This letter is to request a review of several changes planed to the Metorex SIPS probe which is currently covered by Registry NR-0701-D-104-B. These modifications are in the latter stages of design and evaluation but have not yet been formalized. These changes will be implemented in the fall of 1999 and will occur in all probes. Thus, these modified probes will be identified by a serial number greater than a certain number that will be determined at a later date.

Modifications to SIPS Probe NR-0701-D-104-B

The configuration of the detector in the SIPS probe has been changed to achieve better analytical performance. In conjunction with this change a few changes have been made to the mechanical parts of the probe.

FIGURE 10. LOCATION OF DOSE RATE MEASUREMENT POINTS

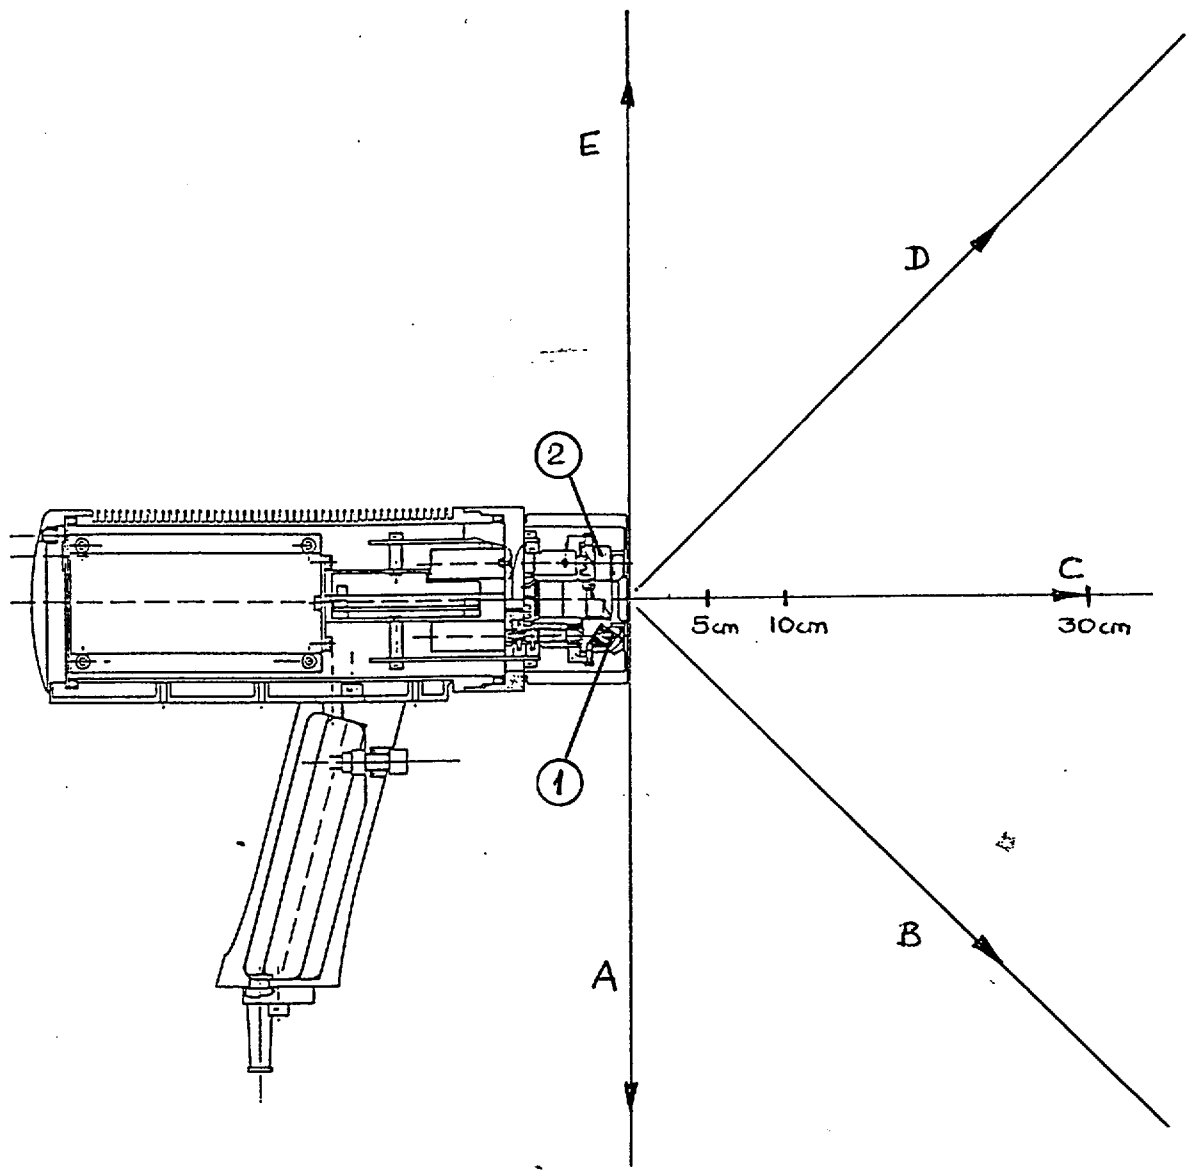
In order to determine the effect of these changes on the radiation profile, measurements were made using the same Cd-109 source in both the current designed probe and the revised probe. Cd-109 was chosen as it has the highest radiation profile in the testing of the original probe. The measurements were made using a Giger counter to monitor the primary beam. A scintillation detector was used to measure the weak radiation in other directions. The following comparative table shows the radiation along the axis illustrated in figure 10 (p9):

These profiles indicate that there is essentially no difference in the radiation profiles of the two designs.
